#### REMARKS

FIG. 2

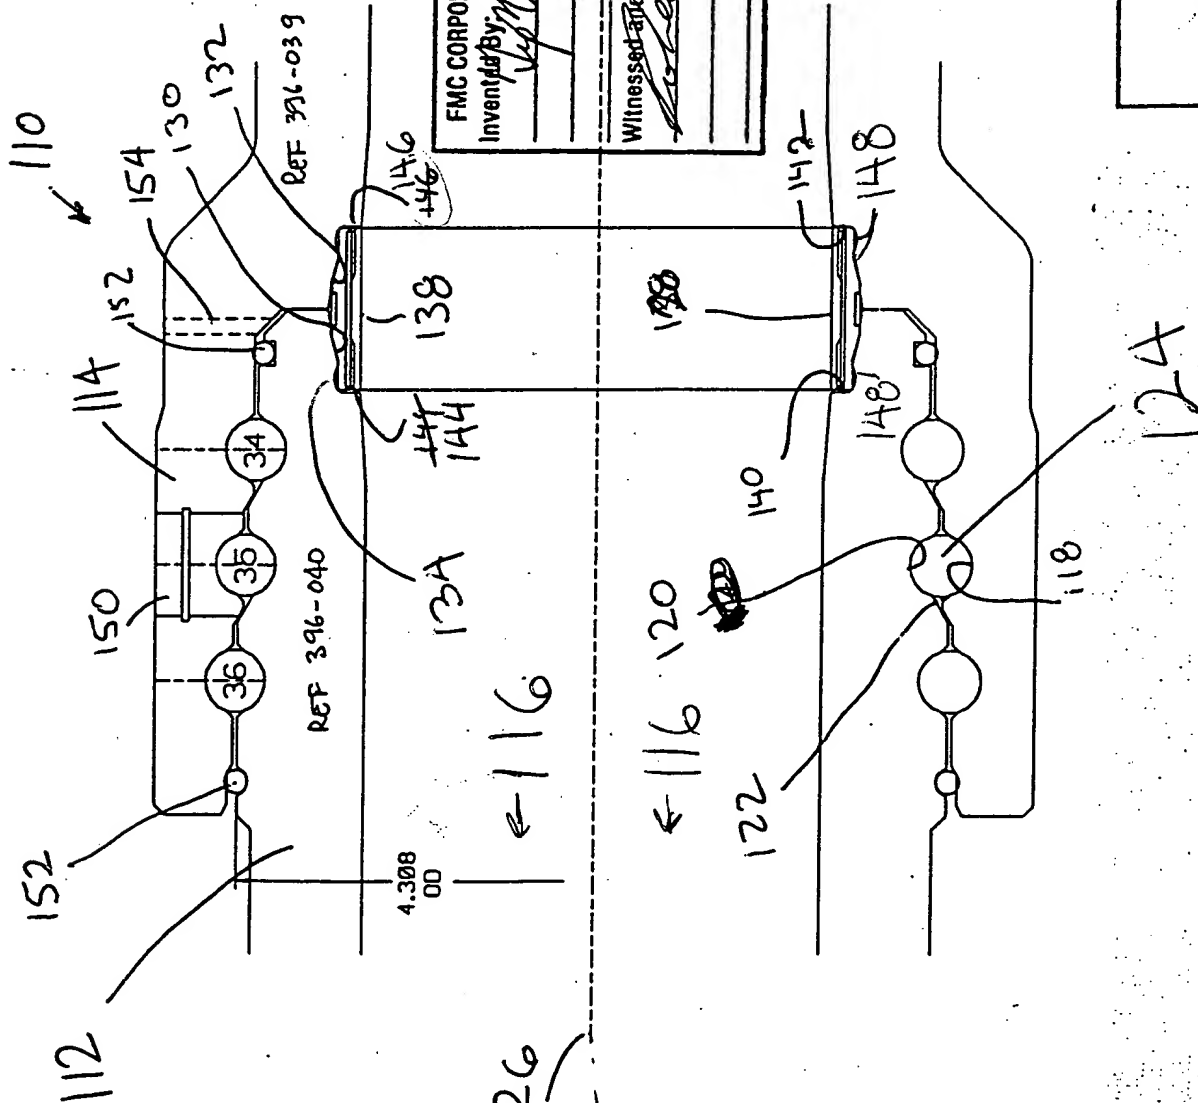
1. The Examiner has indicated that an Abstract of the Disclosure was not submitted earlier. Attached herewith on a separate sheet of paper is an Abstract.
2. The drawings are objected to for not including certain reference signs referred to in the Description. Pursuant to MPEP 608.02(p), attached herewith are proposed changes in red ink, submitted for approval by the Examiner. Upon such approval, formal drawings consistent with the proposed changes will be submitted.
3. The drawings are objected to for failing to designate appropriate portions of Figure 3 as "PRIOR ART". Pursuant to MPEP 608.02(p), attached

drawing  
approved by  
examiner  
AS  
1-18-96

FIG. 3

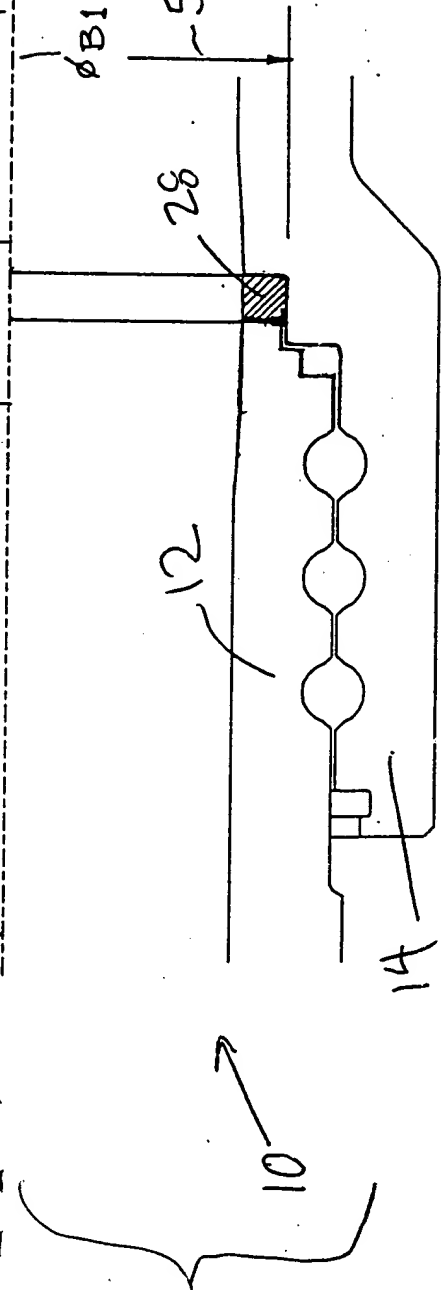
herewith are proposed changes in red ink , submitted for approval by the Examiner. Upon such approval, formal drawings consistent with the proposed changes will be submitted.

PRIOR  
ART
